TCAPS Montessori

Parent Questions & Answers
Virtual Meeting Recap from May 21, 2020

First Floor Plan:

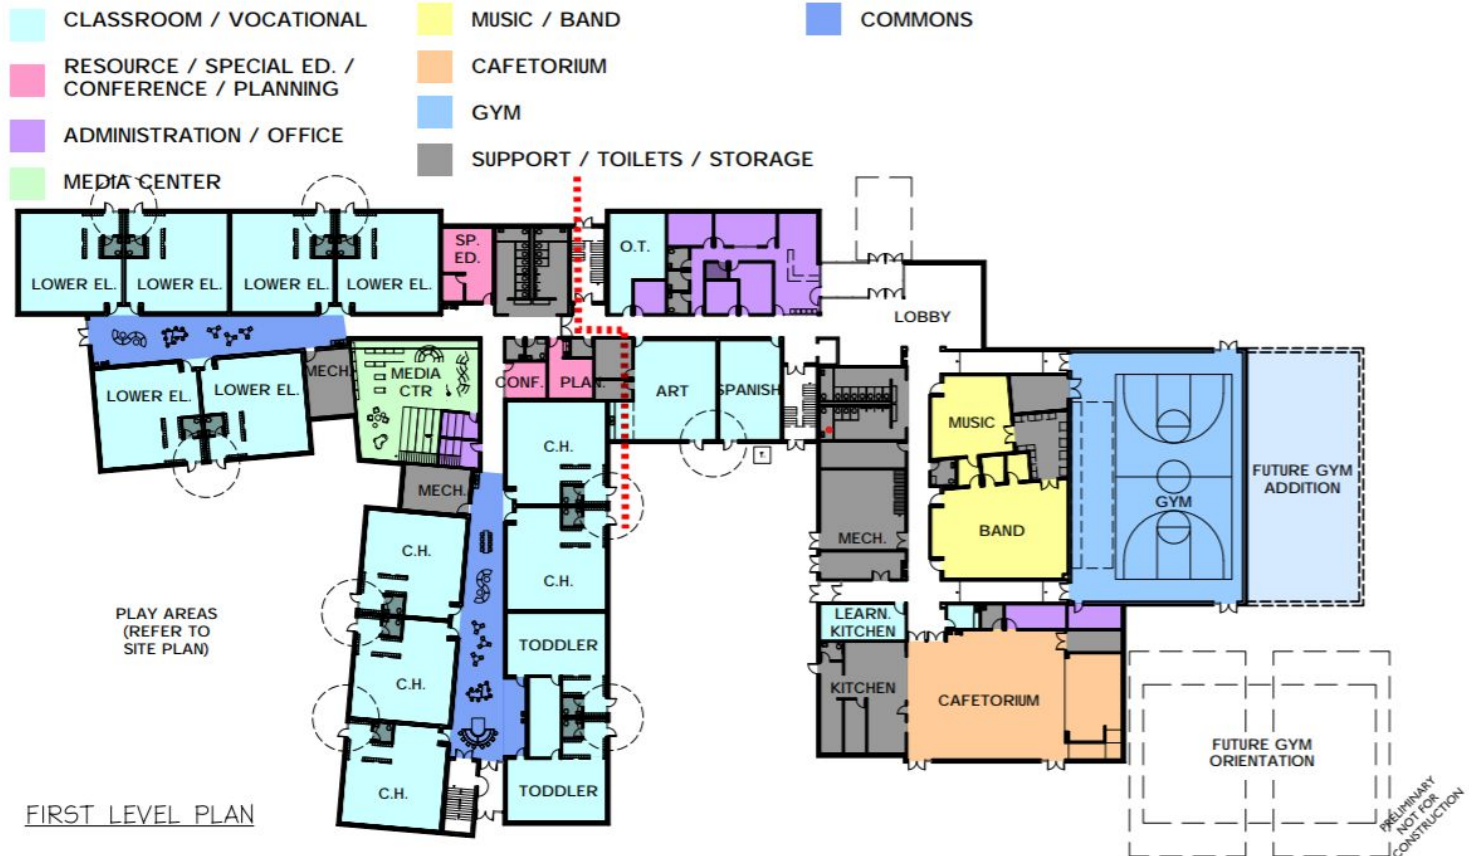
PARENT QUESTION: Is there a library? Could you please identify it on the site plan.

PARENT QUESTION: Will there be a lot of windows in the cafeteria for natural light?

PARENT QUESTION: Could the orientation of the building be adjusted to allow for more south facing glass to help with solar heating?

RESPONSE: Yes, there is a library. It's a two-story space labeled Media Center on the floor plan.

RESPONSE: Absolutely. We envision something similar to Eastern Elementary. A lot of windows with natural light but still planning for a secure pick-up and drop-off for Extended Day.

RESPONSE: The architects are taking this into consideration.
